The Back Bay/ South End Gateway Project

SUPPLEMENTAL INFORMATION DOCUMENT

Chapter 3: Response to Comments

SID - Increase Pedestrian Zone By 2 Feet

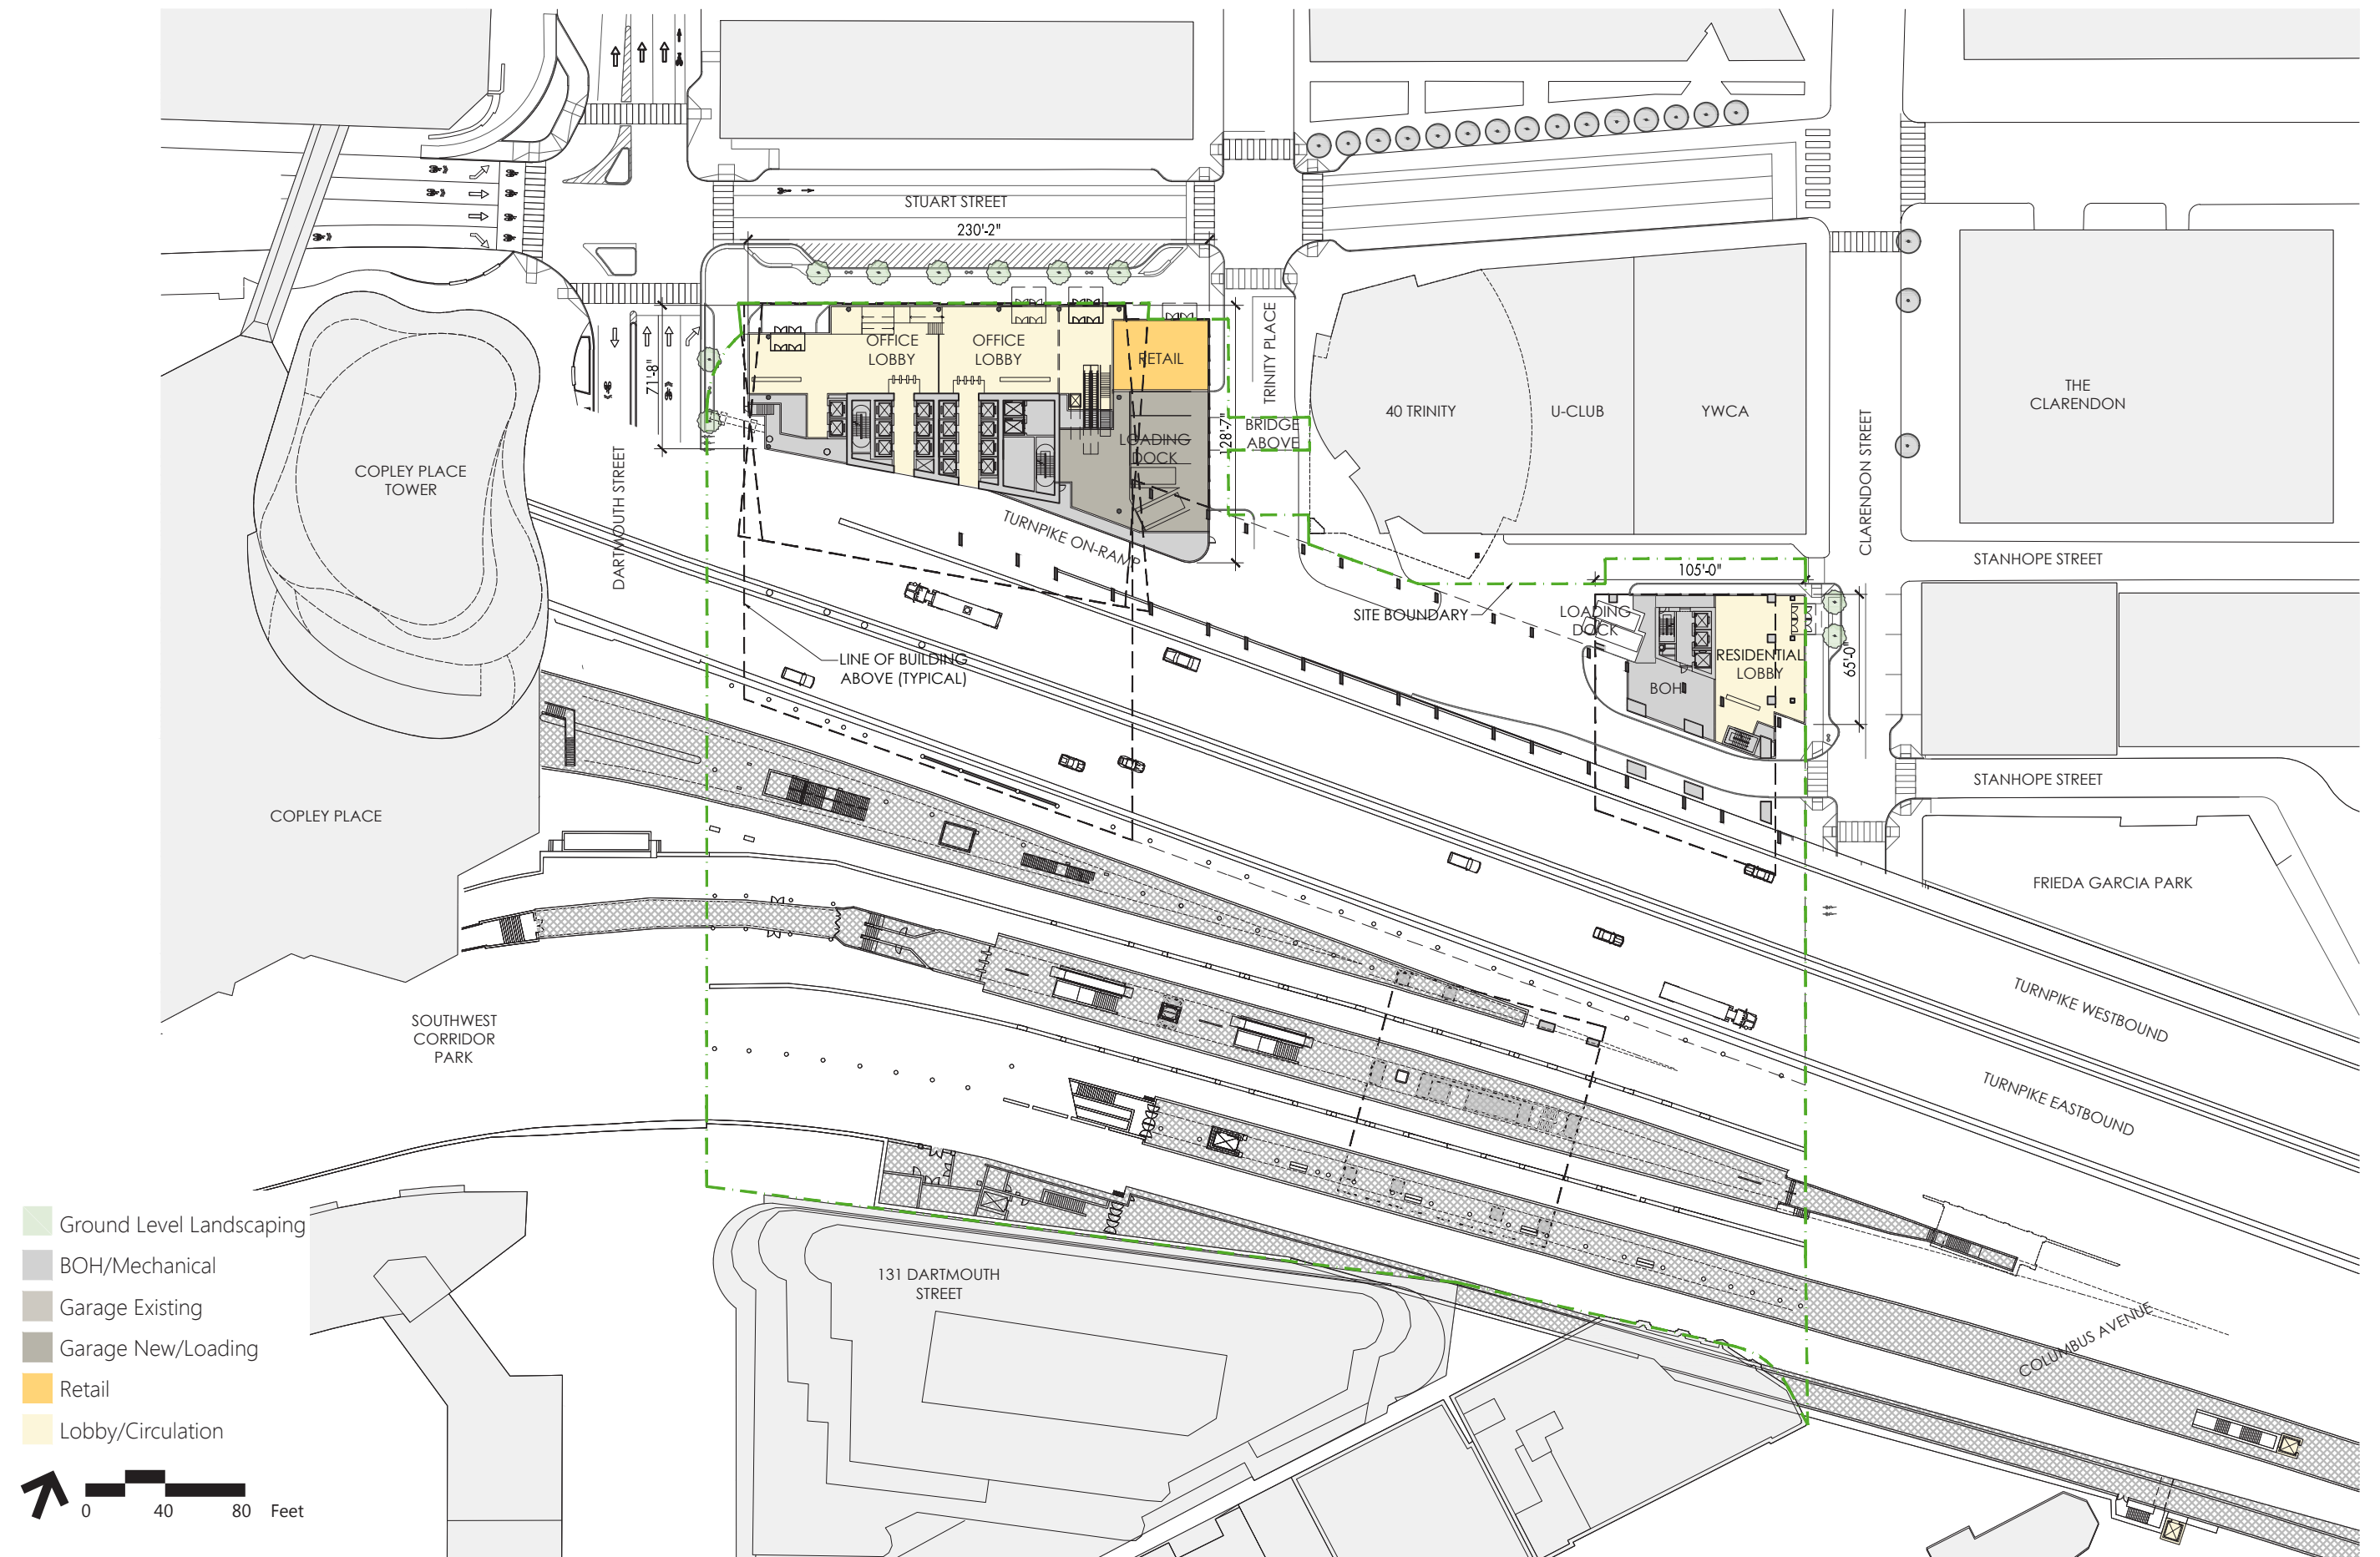
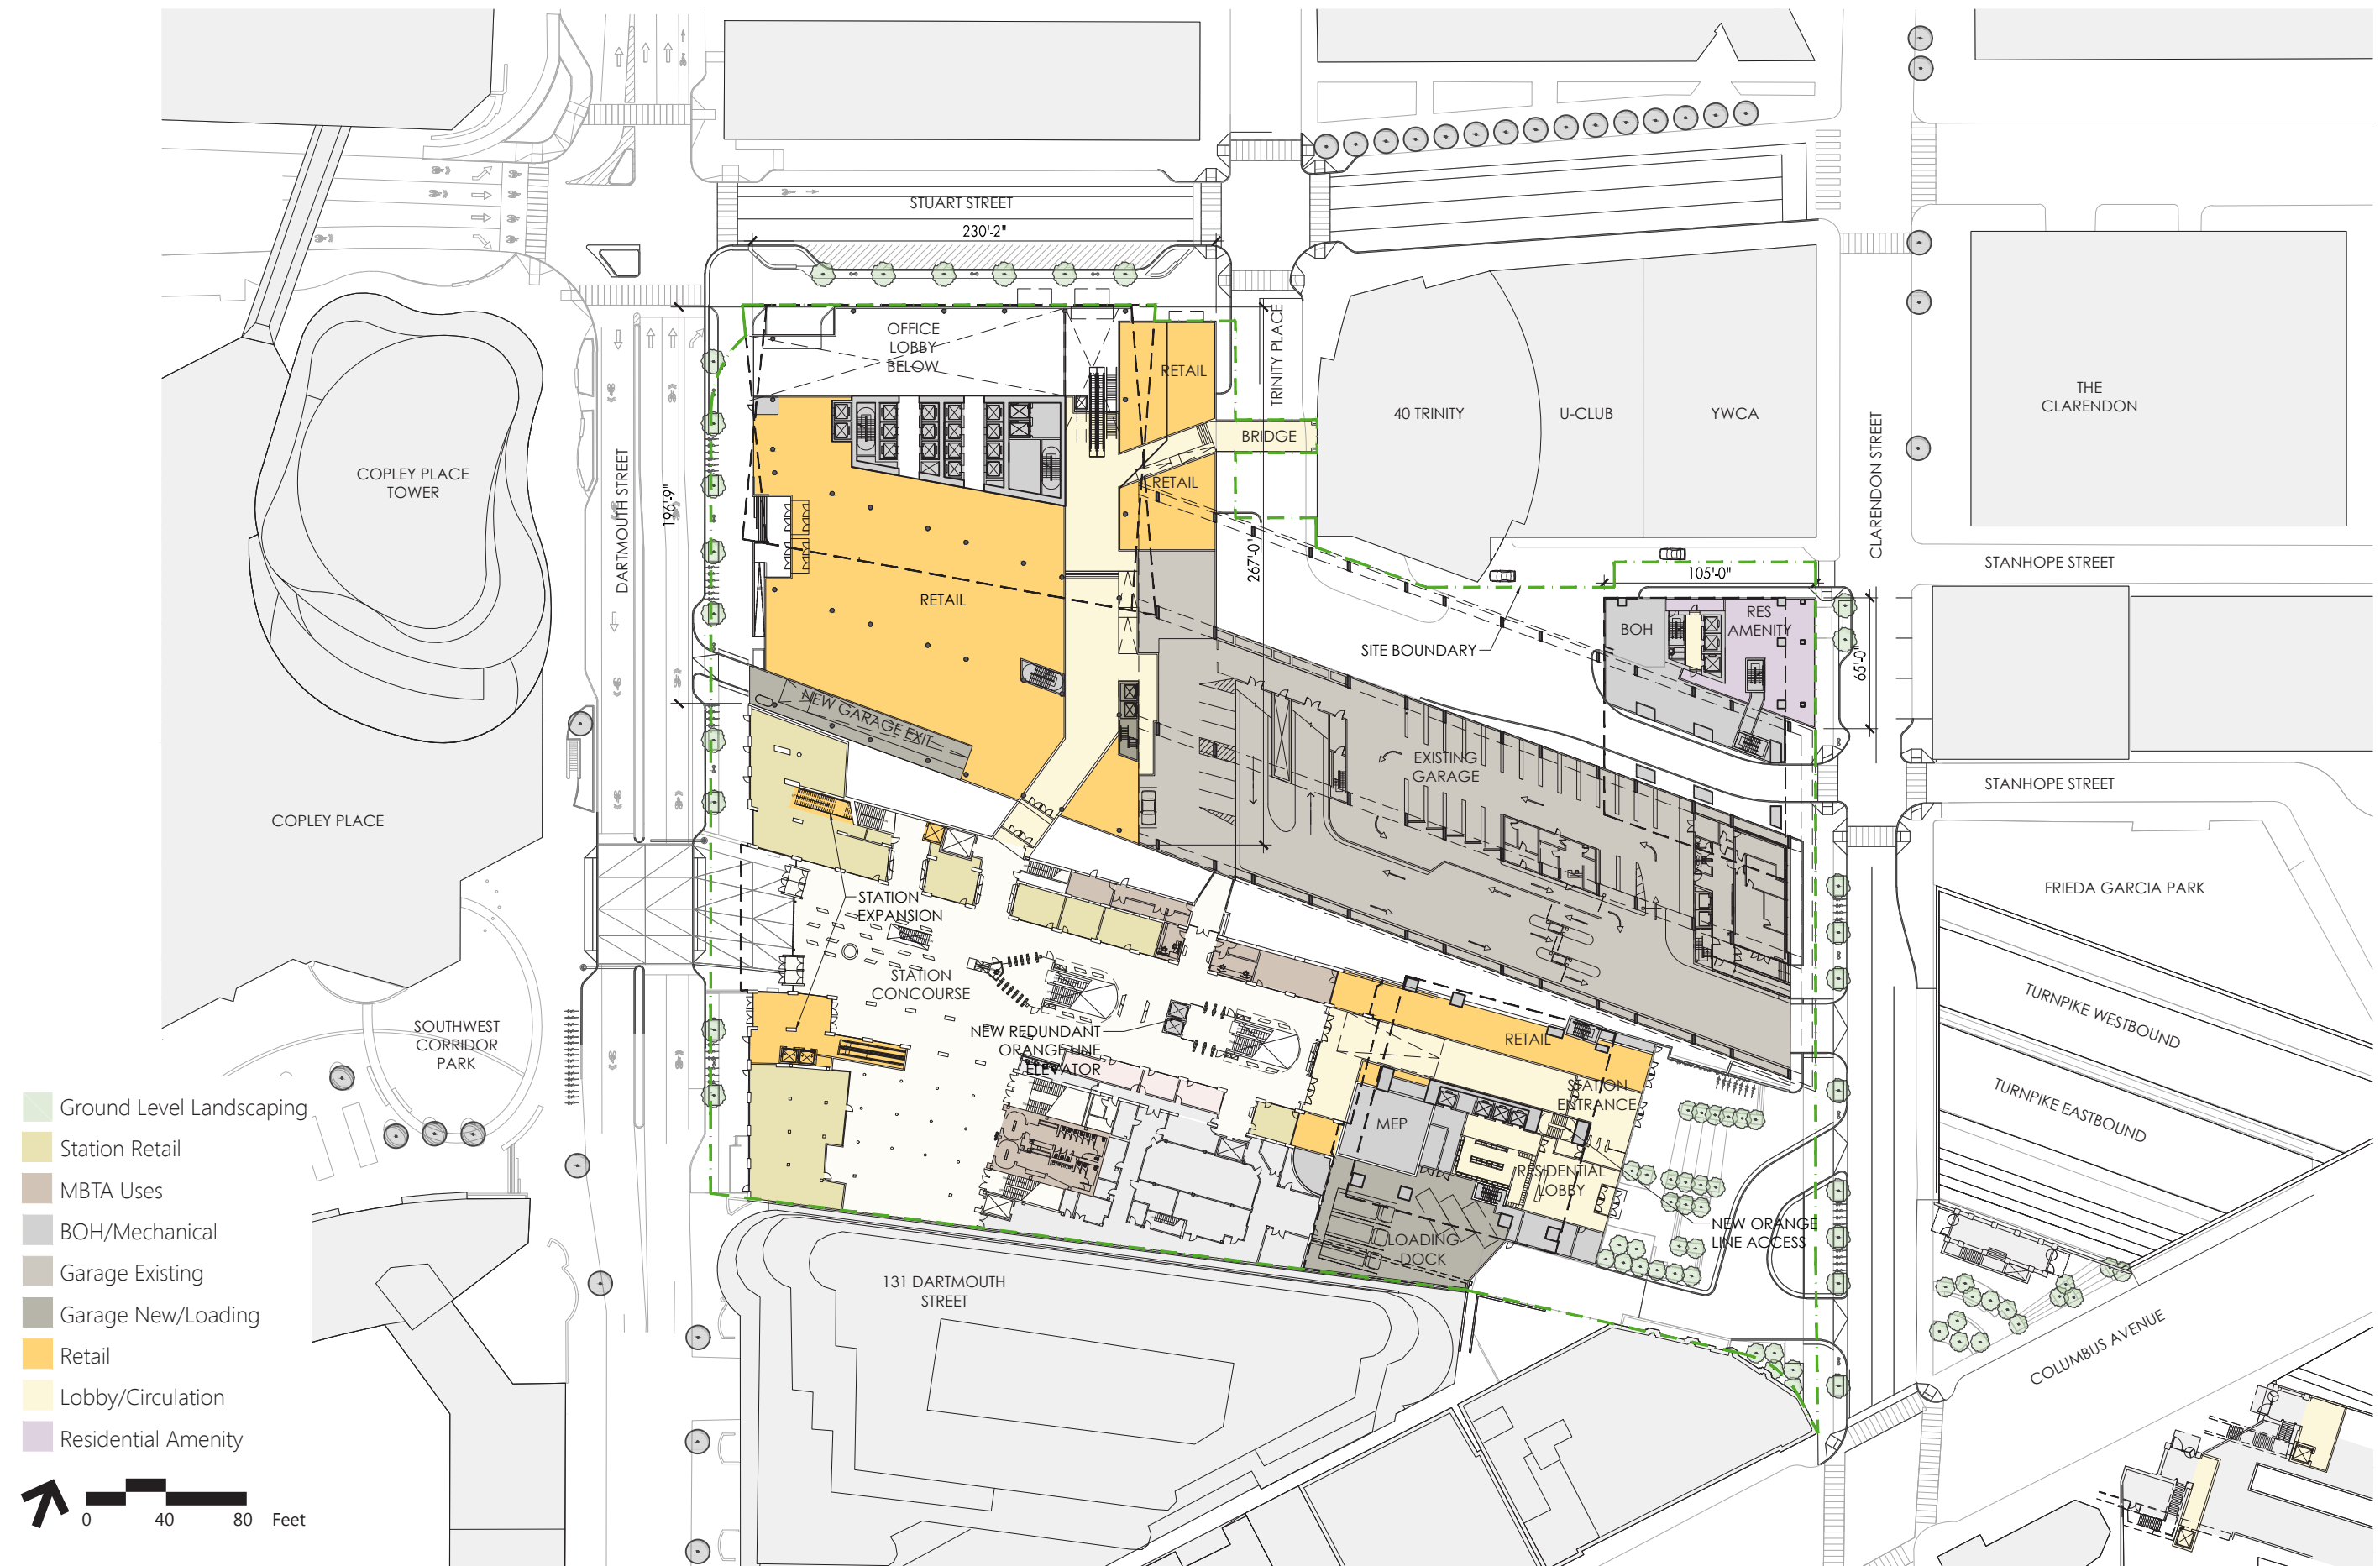
88.4	Stuart Street has greatly improved in simplicity and clarity of connections, especially at the corners. As with all sidewalks here, because of the high amount of pedestrian flows, maximize the width, and in particular allow for easy flows from the improved Station connecting corridor.	<p>Please refer to Section 1.5.2 and to Figures 1.10a-b, for updates on sidewalk dimensions since the DEIR/DPIR, and to Section 2.2 for a detailed description of the Project's public realm improvements, and to Figures 2.7a and 2.7c, for plans detailing public realm improvements along Stuart Street.</p> <p>Since the filing of the DEIR/DPIR, the Proponent has increased the width of the pedestrian zone on Stuart Street from 11 feet to 14.5 feet and decreased the furnishing zone in this area from 6.5 feet to 4 feet. Again, the pedestrian zone exceeds the CSG recommended dimension.</p>

- › **Public Realm Improvements – Sidewalk Dimensions:** In response to comments received on the DEIR/DPIR and in connection with design review with the Boston Civic Design Commission ("BCDC"), the dimensions and articulation of the pedestrian zones have been advanced. Specifically, along Dartmouth Street, the Garage West building footprint at the ground floor has been pushed in two (2) feet, allowing for a widened pedestrian zone of 17 feet (previously 15 feet in the DEIR/DPIR) and increasing the overall sidewalk width from 21.5 feet to 23.5 feet. Please refer to Figure 1.10a and Figures 2.7c and 2.7f.

In addition, the Garage West building footprint at the ground floor along Stuart Street has been pushed in one (1) foot, while the furnishing zone has been reduced from 6.5 feet to 4 feet, reflecting the fact that terra firma exists along this street and that the street trees may be planted in soil. These adjustments allow for a large increase of the pedestrian zone on Stuart Street, which is now 14.5 feet (previously 11 feet in the DEIR/DPIR). The overall sidewalk width will be 18.5 feet, which is a dramatic increase from the 8-foot sidewalk that exists there today. Please refer to Figure 1.10b and Figures 2.7c and 2.7f.
